School Property

Salem, Connecticut

ENVIRONMENTAL REVIEW TEAM REPORT

SALEM SCHOOL PROPERTY

VEGETATION

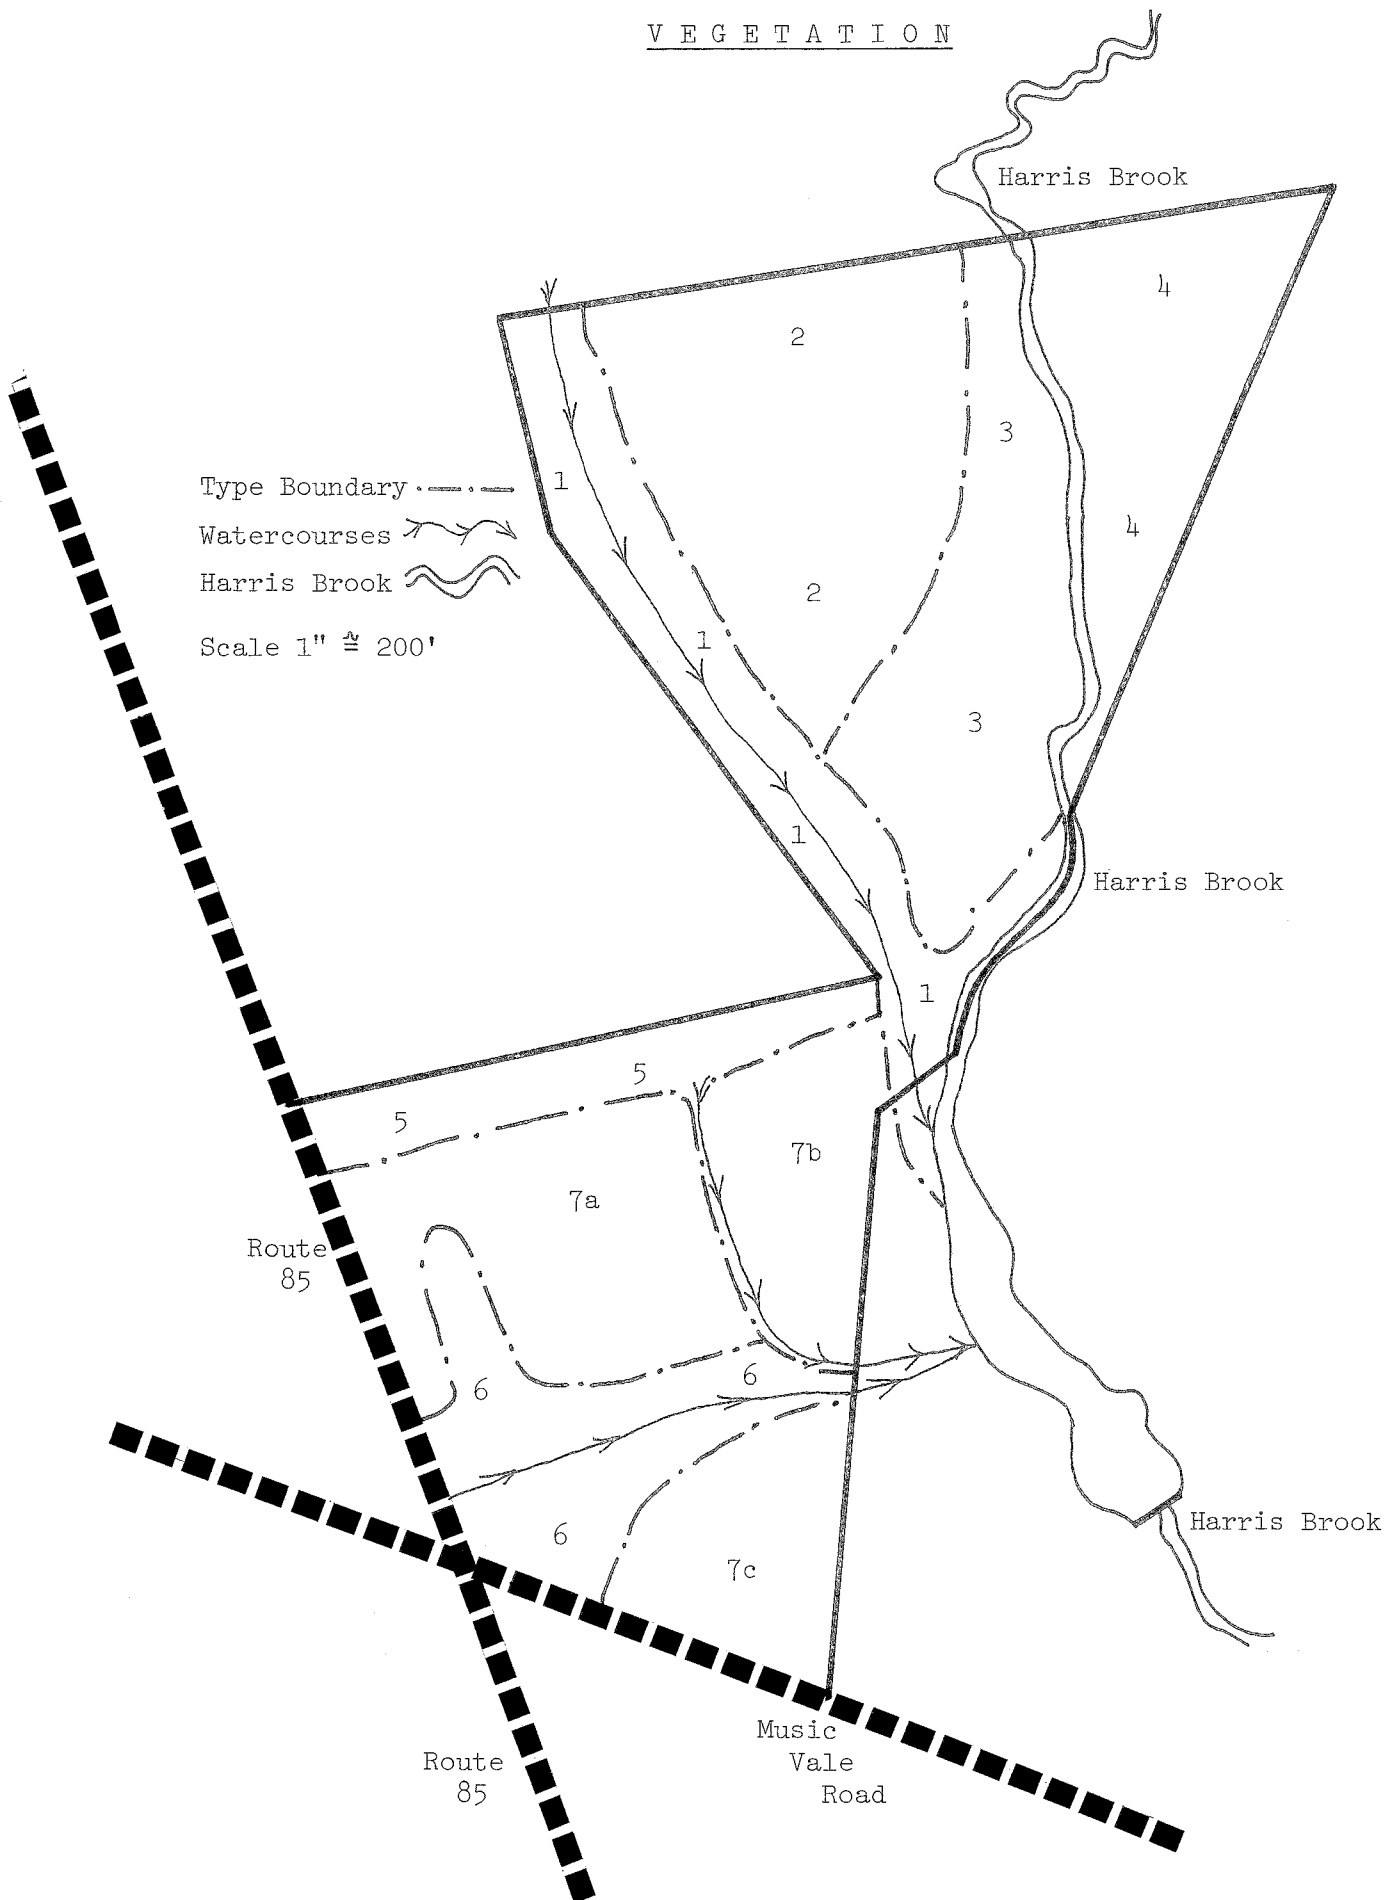
If this area were bridged to provide access to the higher ground to the east for a recreation field or as a septic leach field, care should be taken not to impede the water drainage as a change in the water table will affect adjacent trees.

If some of this parcel was to be designated as a scout camping area, this would seem ideal. It is separated from the rest of the area by the brook, the ground is high and dry and the mature hardwood stand would lend itself to clearing for campsites.

Area #7 - These are open fields that are beginning to show signs of filling in with brush. Seven A and Seven B are separated by a narrow wet drainage area. Seven A has a moderate east to south east slope, and is fairly well drained. Seven B is nearly flat with a fairly high seasonal water table, which would place some limitation on it's use. Seven C is smaller, has a moderate northeast slope and is drier than much of the other two fields. It is separated from 7A and 7B by the drainage area and could only be accessed from Music Vale Road unless the drainage is bridged.

POSSIBLE ARRANGEMENT
OF FUTURE SCHOOL
AND
RELATED FACILITIES

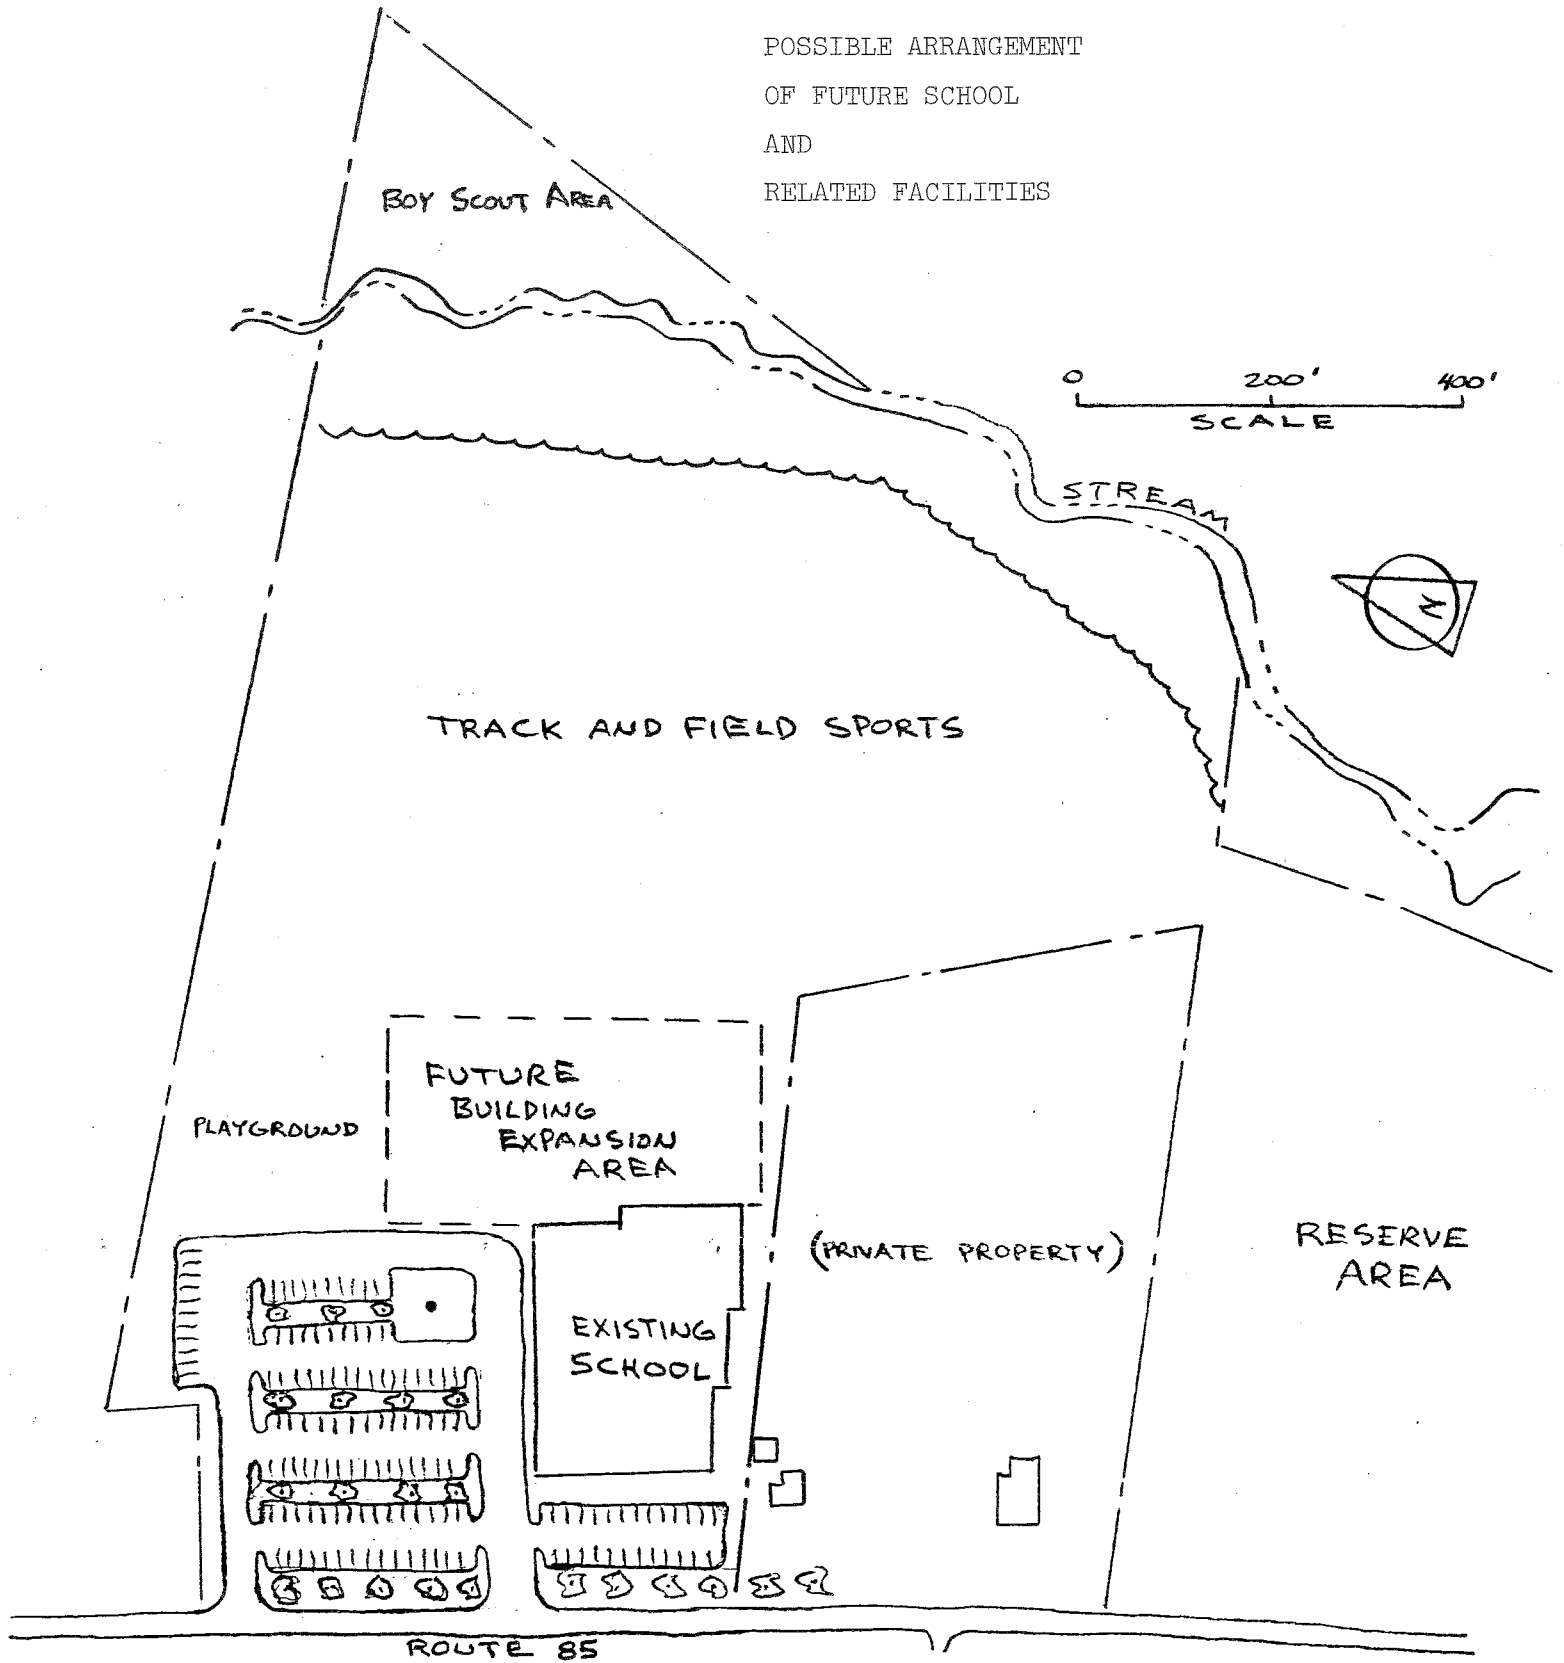
A long-range development plan for the school should include greater use of Route 85 frontage to the north of the school. Consideration should be given to acquisition of the adjoining house lot to the north and relocation of the library. This would provide over 600 feet of frontage on Route 85 in a location that affords reasonably good sight lines in both directions along the busy highway.

With more frontage on Route 85 north of the school, the opportunity for establishing parking areas, recreation facilities, bus loading lanes, and building additions in more reasonable locations and in closer proximity to each other becomes possible.

A possible arrangement of future uses is presented in sketch form on the accompanying illustration. Under this arrangement, the 12+ acre southern part of the parcel would be either held in reserve for some presently unforeseen future use or sold. Future building space needs would be met by adding to the existing school building. Ample driveways and vehicle parking would be convenient to the whole structure. A playground would be located adjacent to the north end of the building, and the large upland area east of the building would be used for field sports. Leaching fields for subsurface sewage disposal systems could be located under the field sports area. The area along the stream at the eastern edge of the property would remain in its natural state and could be used as a camping area for local boy scouts.
